## Permit to Alter Case Report

*Hearing Date:* October 6, 2010  
*Filing Date:* September 22, 2010  
*Case No.:* **2009.1100H**  
*Project Address:* **1095 Market Street**  
*Category:* Category I – Joseph D. Grant Building  
*Zoning:* C-3-G (Downtown General)  
90-X Height and Bulk District  
*Block/Lot:* 3703/ 059  
*Applicant:* Jim Abrams  
Gibson, Dunn & Crutcher  
555 Mission Street Suite 3000  
San Francisco, CA 94103  
*Staff Contact* Tim Frye - (415) 558-6625  
[tim.frye@sfgov.org](mailto:tim.frye@sfgov.org)  
*Reviewed By* Tina Tam – (415) 558-6325  
[tina.tam@sfgov.org](mailto:tina.tam@sfgov.org)

## DRAFT Permit to Alter MAJOR ALTERATION MOTION # XXXXX

PROPOSED ELEVATION OF TYPICAL STOREFRONT ALONG 7TH STREET  
 Scale: 1/4" = 1'-0"  
 0 2 4 8 16 FEET

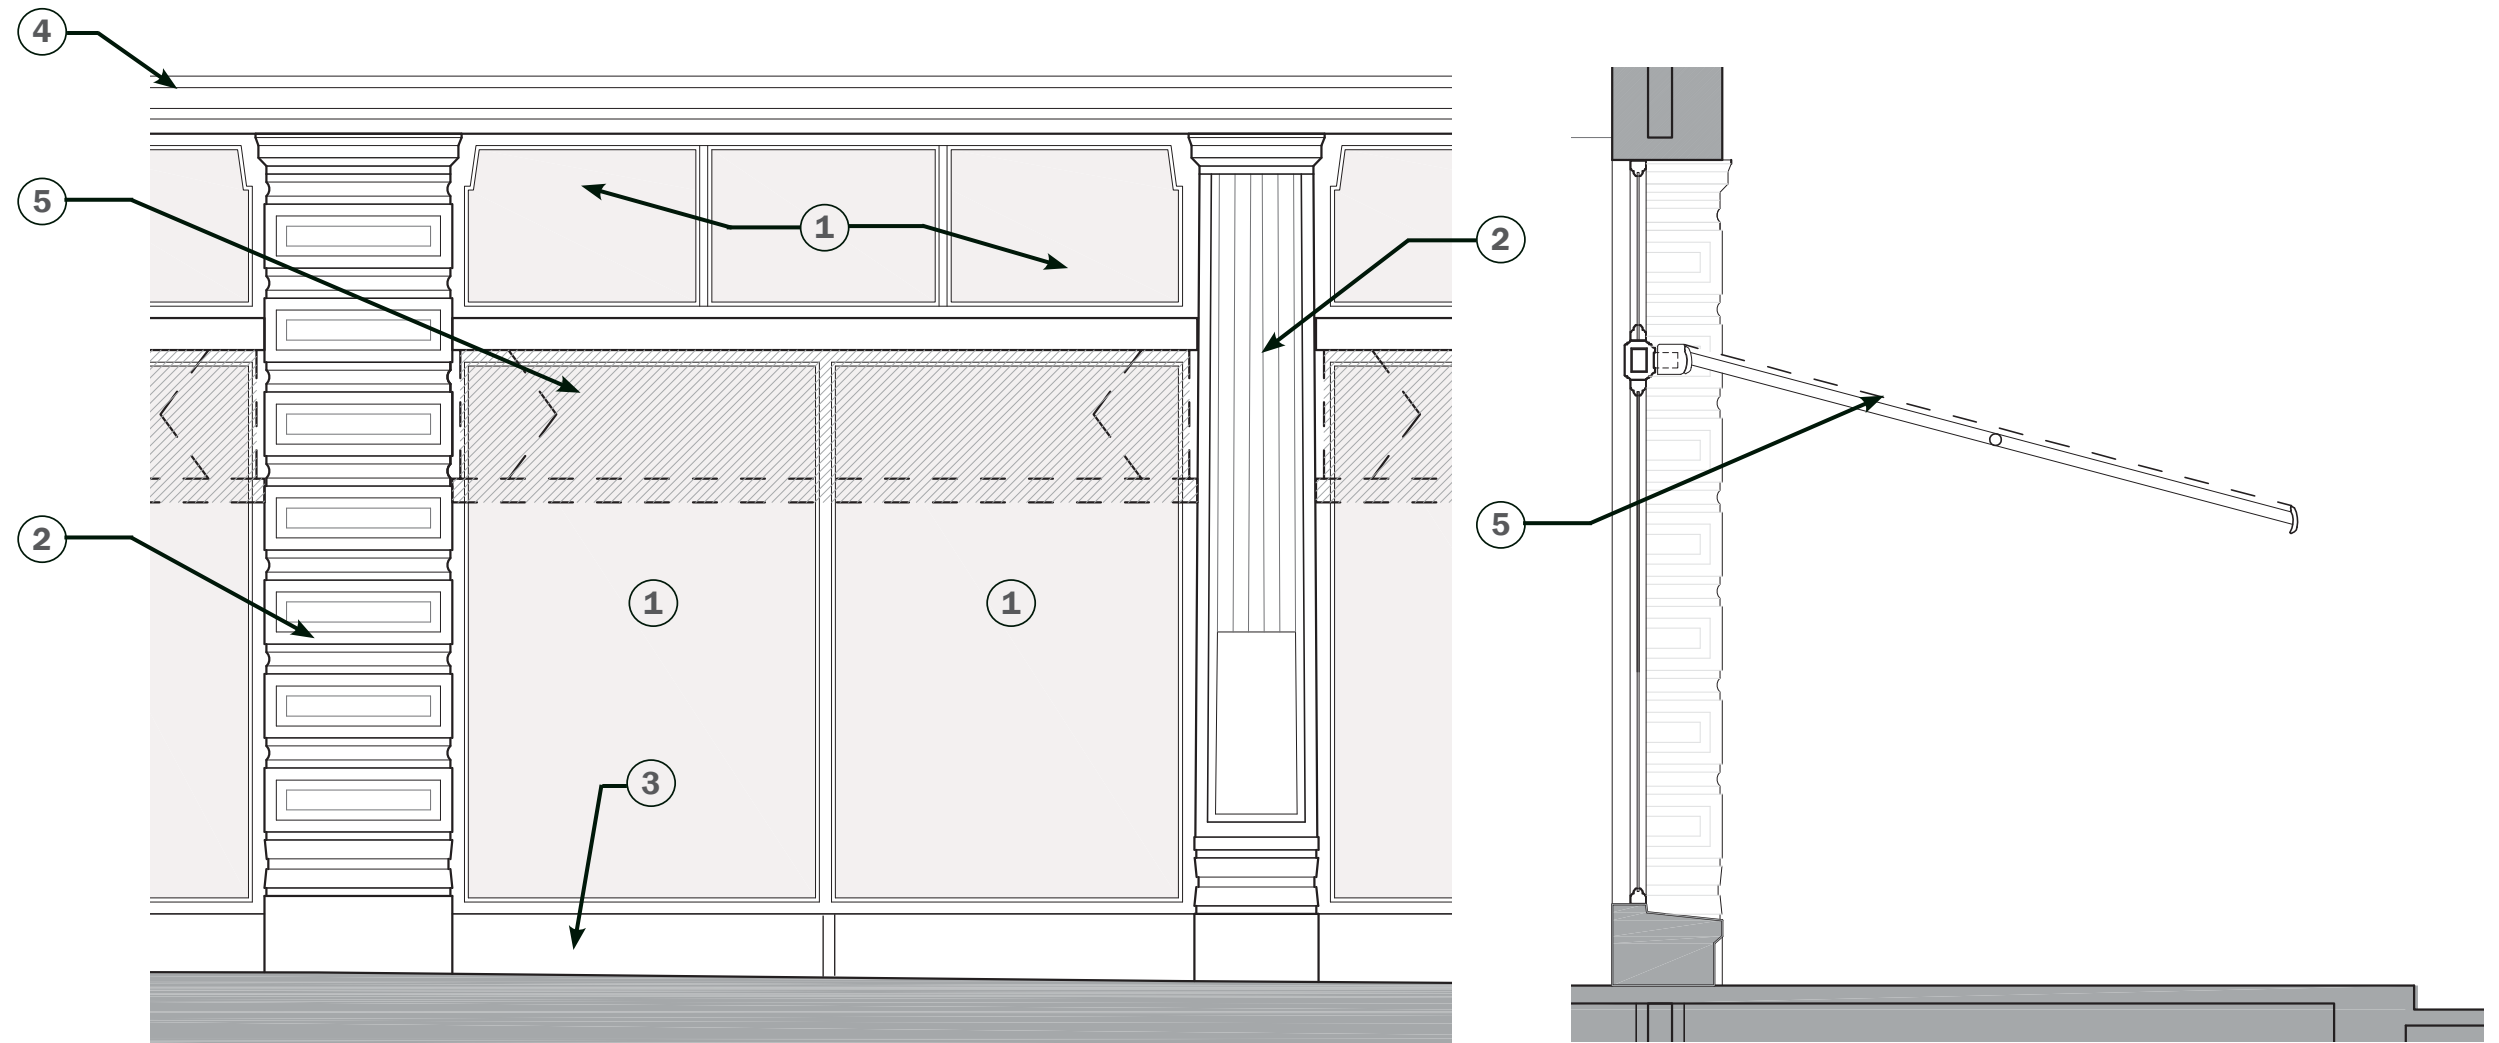
**Canopies and Signage:** New retractable awnings are proposed for each storefront opening along 7<sup>th</sup> Street and Market Street. The angle of the awning may vary from what is depicted in historic photographs due to current code requirements for overhead clearance; however the awnings will be based on the awnings evident in historic photographs. The awnings will be attached to the new storefront systems and will be confined within each storefront bay. The Department believes that the proposed awnings are compatible with the subject building with the following condition:

10. Each awning shall have a free hanging valance.

EXISTING WINDOW SECTIONS & PLANS AT LIGHTWELL

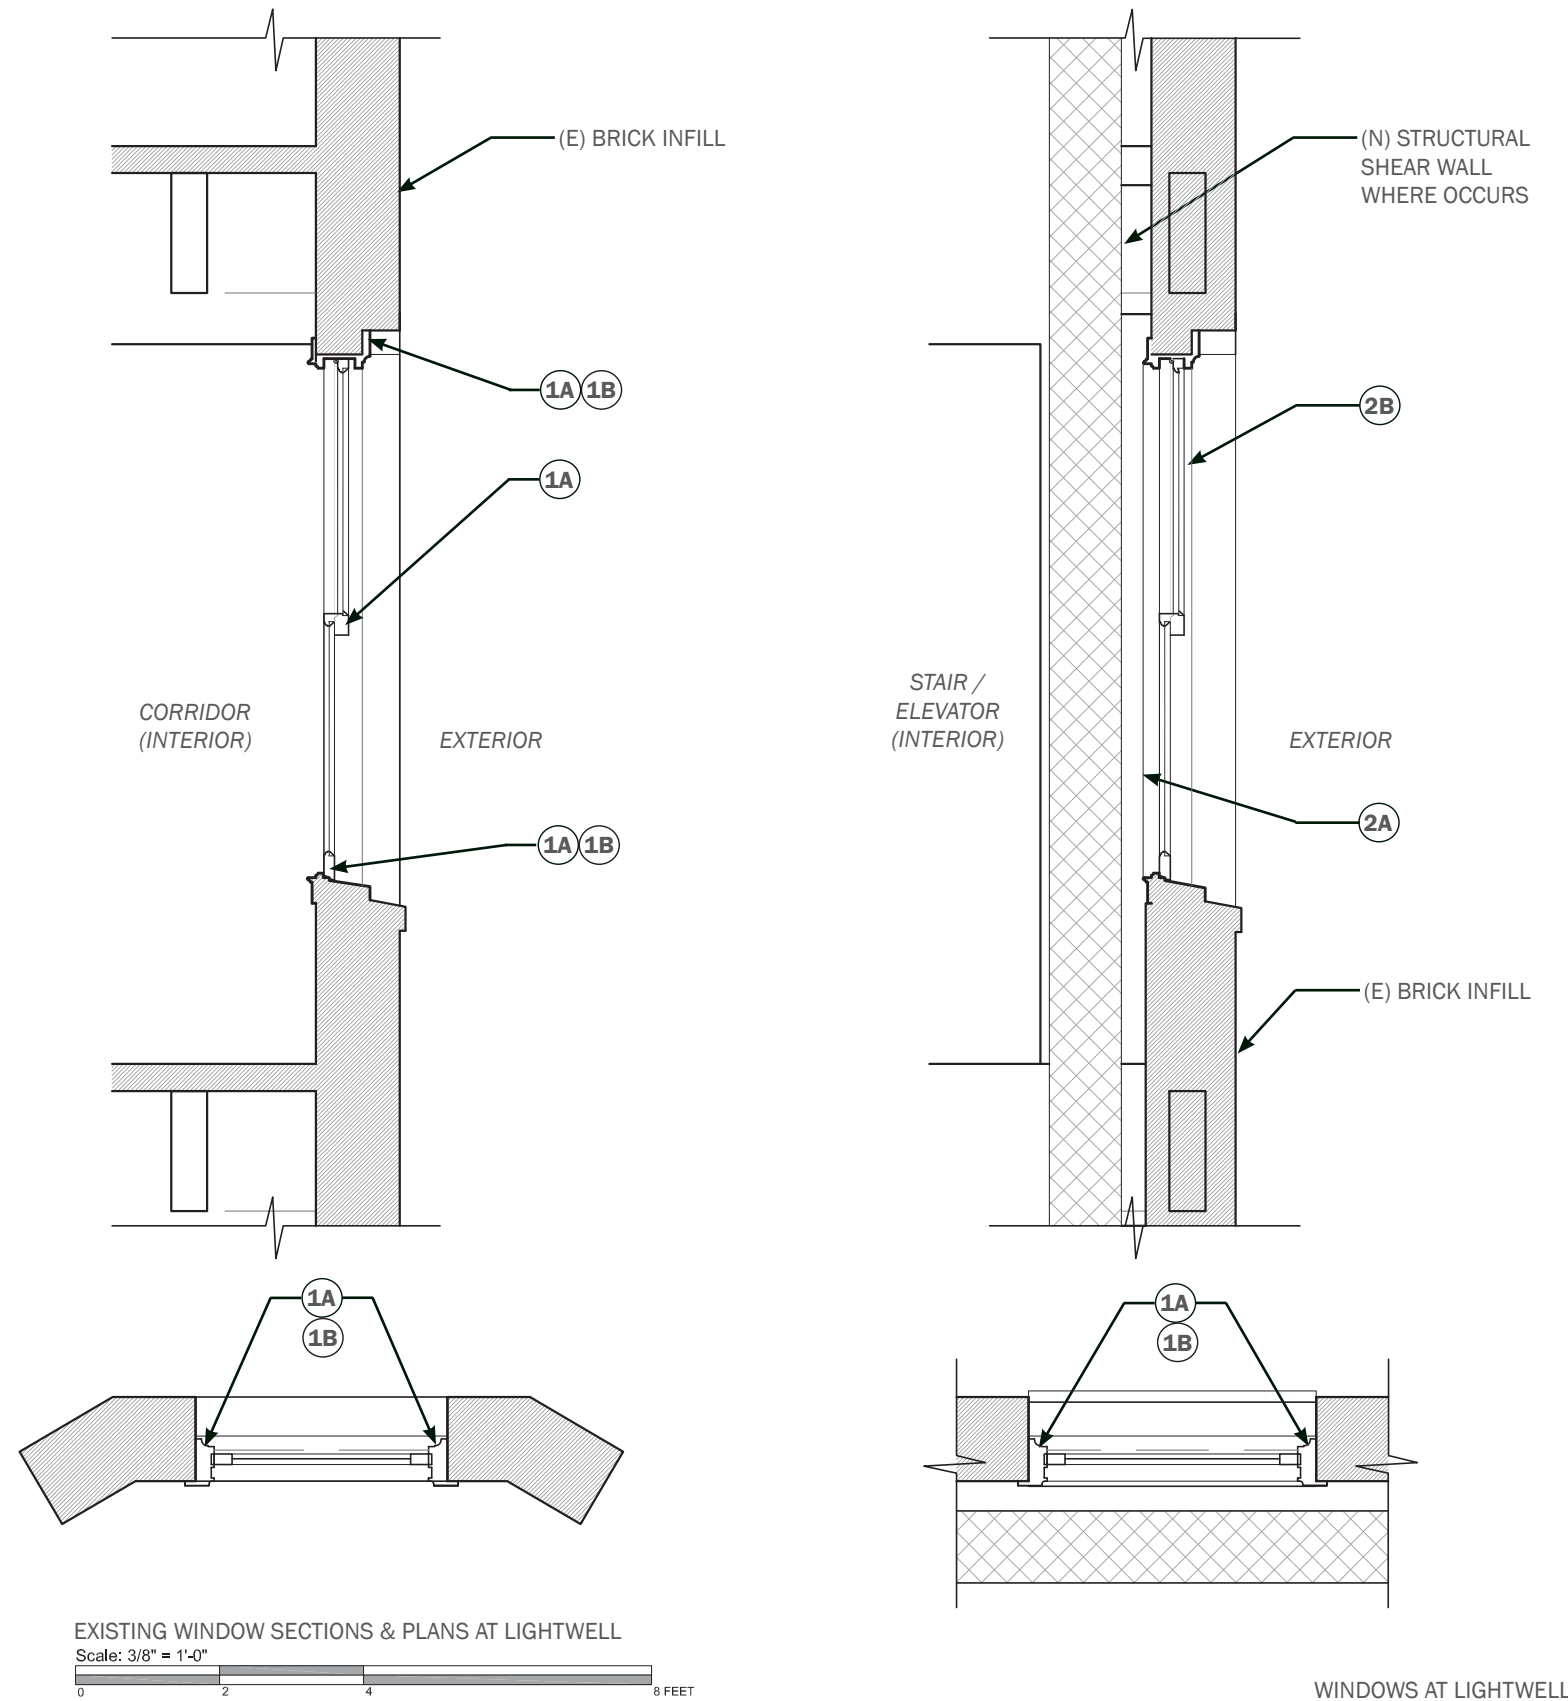
Some windows that face the light-well will be impacted by the seismic work (shear walls) associated with the Project. The Project includes the retention and repair of these windows; however, a painted panel will be installed on the inside of the window frame to obscure the seismic work from view. Please see the floor plans for the locations of obscured windows within the light-well. The Department believes that the approach proposed by the Project team is in conformance with the Secretary of the Interior's Standards; the light-well is located on a secondary elevation that is only visible over the roofline of an adjacent property; while some window openings will be obscured, all materials associated with the historic window and the opening will be maintained and can be accessed for routine maintenance and repair from the exterior; the glazed area will still give a sense of depth and will reflect light in a similar manner as they did historically.

9. All windows are intended to be retained and repaired, however 20% or less of the windows may be replaced if upon further inspection it is determined that they are beyond repair. Any deviation from this condition of approval, such as further inspection determines that more than 20% of the windows require replacement or the use of substitute materials, shall require review and approval by the Historic Preservation Commission.

ELEVATION OF PROPOSED CORNICE

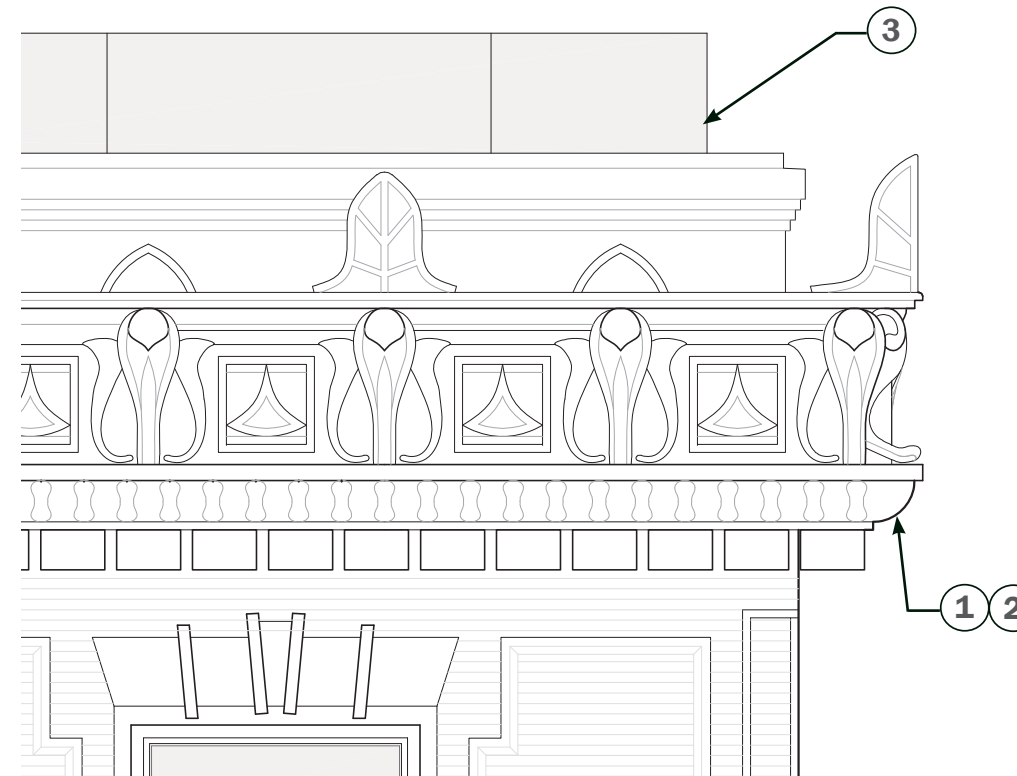
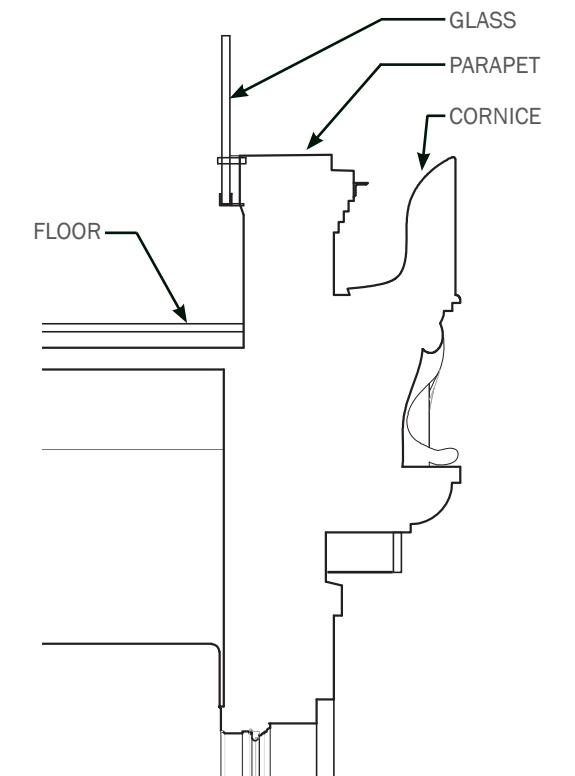
**Cornice Reconstruction:** The historic cornice was removed from the building prior to designation as a Category I building under Article 11. The Sponsor proposes to construct a new cornice based on physical and photographic evidence. The proposed cornice will be constructed of Fiber-Reinforced Polymer (FRP) and will be attached to the existing parapet in the same location as the historic cornice feature.

According to the Secretary of the Interior's Standards, the use of substitute materials for wholesale replacement or replication of a missing historic feature is an acceptable treatment provided that the work is based on documented, physical, or photographic evidence. FRP is widely used as a substitute material for large architectural features. FRP is more cost efficient than terra-cotta or other traditional building materials in terms of production and installation. The proposed elevation and section drawings submitted by the Sponsor illustrate some features evident in the historic photographs; however, the details should be further refined to provide a closer match to the historic cornice. The Department

1. The shop drawings shall be included in the architectural addendum and are subject to review and approval by Department Preservation Staff to ensure that the replacement cornice closely matches all exterior profiles, dimensions, and detailing of the historic cornice
2. Prior to the production of the replacement cornice and the approval of the architectural addendum, Department Preservation Staff shall review site mock-ups of the FRP panels, including a mock-up of the exterior finish. The results of the site mock-up and all finish samples shall be presented at a future hearing to the Historic Preservation Commission for review and approval.

1. The shop drawings shall be included in the architectural addendum and are subject to review and approval by Department Preservation Staff to ensure that the replacement cornice closely matches all exterior profiles, dimensions, and detailing of the historic cornice.

2. Prior to the production of the replacement cornice and the approval of the architectural addendum. The Department Preservation Staff shall review site mock-ups of the FRP panels, including a mock-up of the glaze samples. The results of the site mock-up and all glaze samples shall be presented at a future hearing to the Historic Preservation Commission for review and approval.
